# Joint Regional Planning Panel

17 October 2012

<b>JRPP Number:</b>	2012SYE074
<b>DA Number:</b>	DA-2012/180/A
<b>Local Government Area:</b>	ROCKDALE
<b>Proposed Development:</b>	S96 Application – Integrated Development - Modification to approved development to include twelve (12) additional residential units to create a total of 162 residential units and 200 carparking spaces
<b>Street Address:</b>	52 Arncliffe Street, WOLLI CREEK NSW 2205
<b>Applicant/Owner:</b>	Urban Link Pty Ltd
<b>Number of Submissions:</b>	Nil
<b>Recommendation:</b>	Refusal
<b>Report by:</b>	Fiona Prodromou

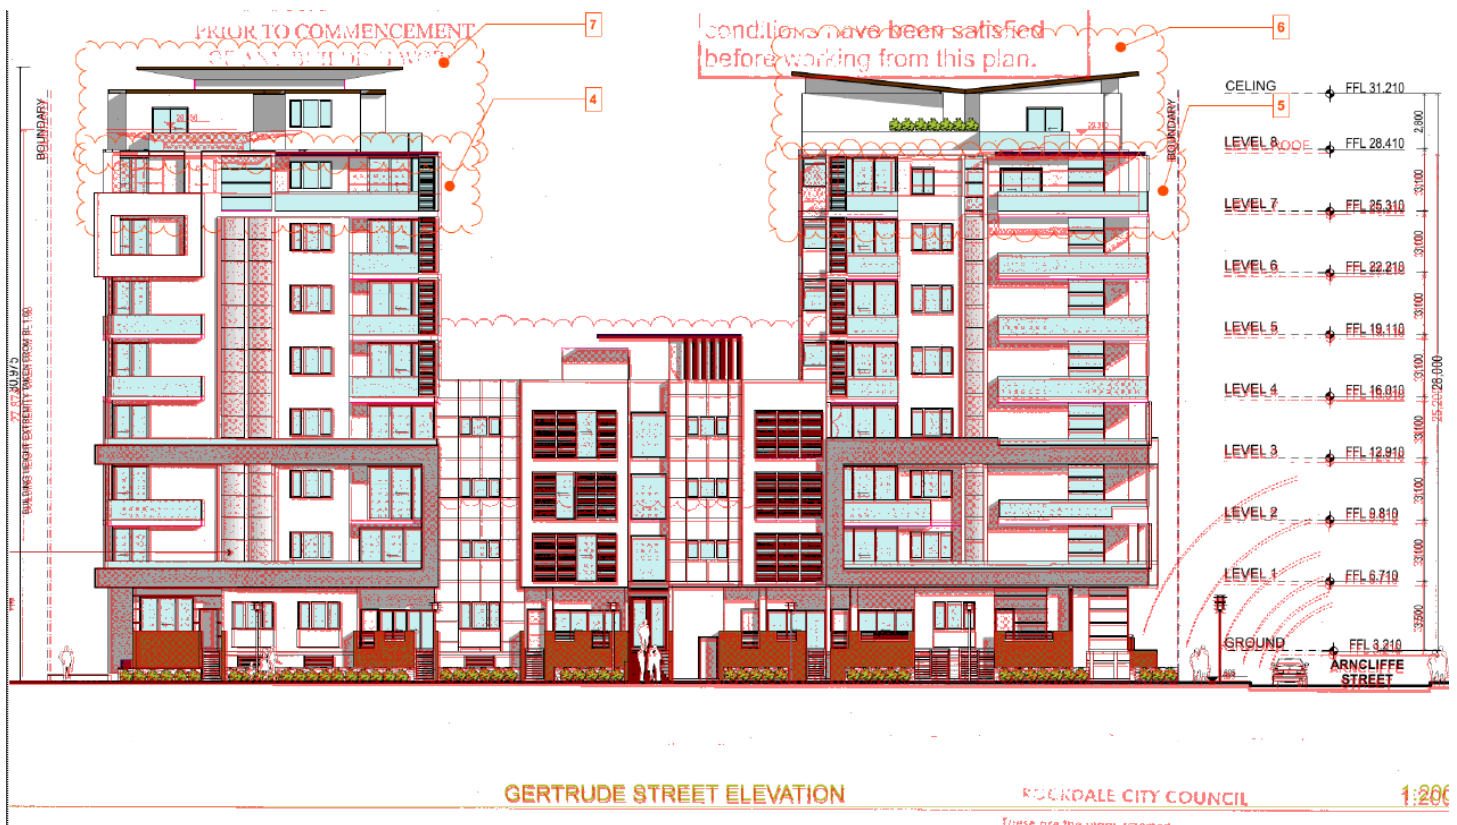
The applicant has not submitted additional shadow diagrams, indicating the potential overshadowing likely to be generated on site to ground level communal open space and its own buildings, as a result of the proposed increase in height. The extent of additional overshadowing likely to be generated from the proposed modifications is therefore unknown.

It is considered that the proposed additional height and the increased width of level 7, has the potential to provide additional overshadowing to the ground level communal open space areas as well as the northern elevation, being primary living areas, balconies, bedrooms and kitchens, of units within the south east building on the site.

The majority of units within the south eastern building on site have their only balconies and primary living areas facing into the site in a northerly direction. Concern is raised regarding the potential additional loss of solar access to these units, as a result of the proposed development, which will subsequently impact on the overall amenity of these units. The proposal is not considered to satisfy the following objectives of Clause 4.4.2 – Solar Access.

The images below provide a comparison between the approved and proposed elevations. The red overlay reflects the approved development, overlaid onto the proposed modifications. The additional height proposed, changes to the articulation and increase in width of the level 7 floor plate can be seen.
